# Product Change Notification

## POWER TVS DIODES

## Bourns® Model PTVS10-0xxC-M Series High Current Power TVS Diodes *Change to Terminal Layout*

**Existing Terminal Layout**

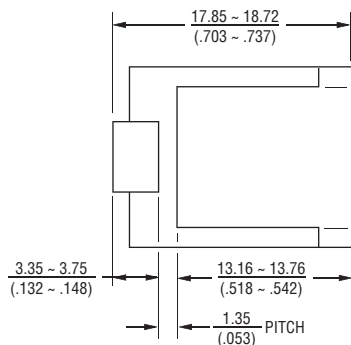
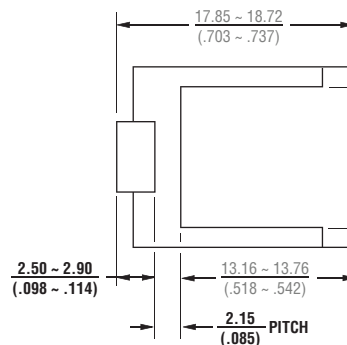
In the spirit of continuous improvement, Bourns is making a change to the pad layout for the Bourns® Model [PTVS10-0xxC-M](#) Series High Current Power TVS Diodes. The pitch between the two terminals is being increased from 1.35 mm to 2.15 mm.

The change to the terminal layout has no impact on the form, function, quality or reliability of the product. The only impact to “fit” is the change in terminal layout for increased pitch. The product marking and label will remain unchanged.
